Spokes strongly supports the North Edinburgh Connections project. Apart from the section on Ferry Road, the project will deliver a safe, continuous cycle route, with the potential to connect to new and existing cycle routes within a significantly growing area of the city. Indeed, we would particularly like to commend the attention paid to connecting to existing infrastructure to the north: this is an example of good practice sometimes absent in other projects.

### **Project Comments**

### Sheet 3

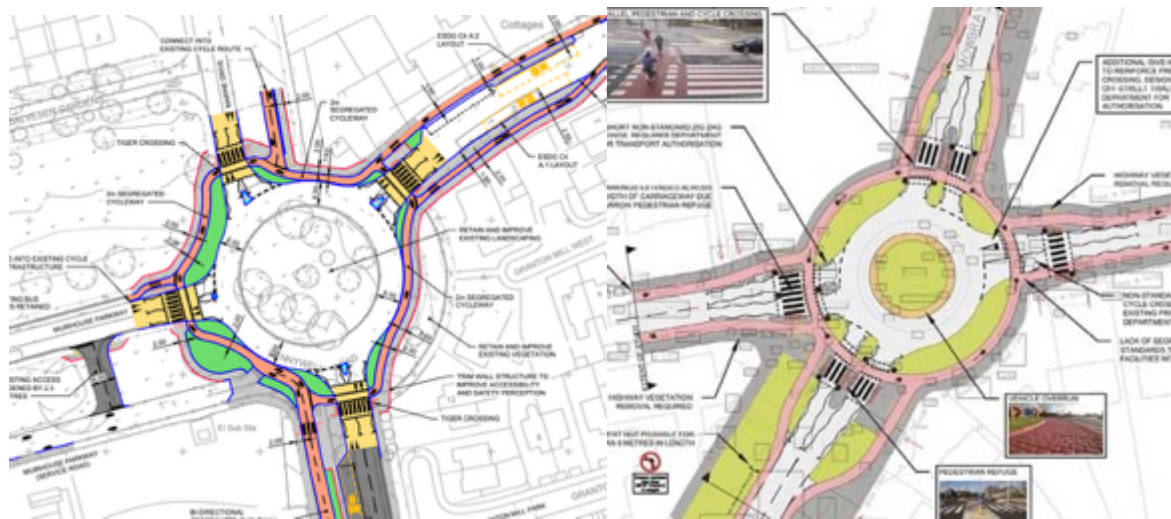
The proposed arrangement at this major roundabout is a significant improvement and we support the principle embodied by the design here. Raised crossings are key and should be installed at each of the exits, as we are concerned that the 30mph speed limit and wide radius of the junction will lead to relatively high traffic speeds approaching the tiger crossings. One simple adjustment would be to ensure that the alignment of the exits forces vehicles to turn at close to 90 degrees to exit from the roundabout: this is generally accepted to reduce traffic speeds. For example, the exit to Marine Drive appears to be much less acute than this, which may encourage a higher approach speed to the crossing there.

Although we are aware of the need for Lothian Bus vehicles to use this roundabout, the radius of the roundabout would seem to encourage higher vehicle speeds. Please see the scale of the Cambridge 'Dutch Style' roundabout which has a 15m diameter island and 38m diameter cycle track. For the NE Connections proposals the existing roundabout of 36m diameter is retained unchanged. This roundabout could fit within the central island at Muirhouse.

It appears the roundabout is too large for the type of cycle friendly design and existing road space should be reallocated for walking and greening via SUDS etc and allowing for a continuous circular cycleway geometry without unnecessary turns for cycle users. The roundabout has not really changed since the 1950's when it was first built apart from trees growing within it.

As can be seen in the comparison of drawings (not to scale) the Cambridge roundabout cycleway is a continuous circle (like for motor vehicles) whereas Muirhouse this is not the case and cycle users have to slow to cross junction arms and it will be hard for drivers to tell if a cycle is continuing around or exiting the roundabout.

The mix of bidirectional and unidirectional cycleways at various points around the roundabout at Muirhouse contrasts starkly with Cambridge where there is a consistent unidirectional entry and exit (even if the roads adjoining do not have unidirectional segregation). Spokes has concerns this variety may lead to wrongway cycling around the roundabout which would be especially dangerous given the novelty of the design in Scotland.

Reduction in overall diameter will also reduce crossing times for pedestrians by shortening the distances and also any loss of central inaccessible vegetation would be gained by having more accessible greenspace to the perimeter closer to people walking and wheeling.
